Xian, China – 27 – 31 July 2009

Question: 4/15

SOURCE¹: CopperGate CommunicationsTITLE: G.hn: Using Two Symbols for the Header of a PHY frame on Coax

Figure 7-10/G.9960 – Functional diagram of the Header Encoder

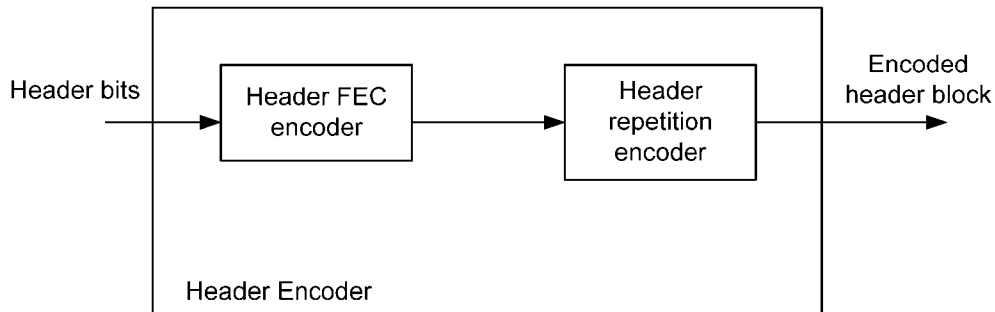
The functional model of the header encoder is presented in Figure 7-10. It contains an FEC encoder and a Header Repetition Encoder (HRE).

The bits of the PHY-frame header shall input the Header FEC encoder in their original order and encoded as described in §7.1.3.2. The size of the FEC codeword and the coding rate of the Header FEC encoder are described in Table 7-19.

The FEC codeword enters the HRE. The HRE shall operate as follows:

- The FEC codeword shall be first copied M times, where $M = \text{ceiling}(D \times k_H / N_{FEC})$, k_H is the number of bits to be loaded onto the OFDM symbol carrying the header, and D is the number of symbols to be used for header transmission
- The encoded header block shall be formed by concatenation of M copies of the header FEC encoder output. As each codeword is cascaded to one another, the bits (b_i) within a codeword shall be cyclically shifted by 2 bits as follows:
 - The 1st FEC codeword copy shall be formed as $\{b_0, b_1, \dots, b_{N_{FEC}-2}, b_{N_{FEC}-1}\}$.
 - The 2nd FEC codeword copy shall be formed as $\{b_2, b_3, \dots, b_{N_{FEC}-1}, b_0, b_1\}$.
 - The 3rd FEC codeword copy shall be formed as $\{b_4, b_5, \dots, b_{N_{FEC}-1}, b_0, b_1, b_2, b_3\}$.
 - ...

- The M^{th} FEC codeword copy, where $M > 3$, shall be formed as $\{b_{(2 \times M - 2)}, b_{(2 \times M - 1)}, \dots, b_{N_{\text{FEC}} - 1}, b_0, b_1, \dots, b_{(2 \times M - 4)}, b_{(2 \times M - 3)}\}$.

Valid values of D are either 1 or 2. Details ~~for powerline and phoneline~~ are for further study.

~~For coax (baseband and RF) the number of PHY-frame header shall be two, i.e., $D = 2$.~~
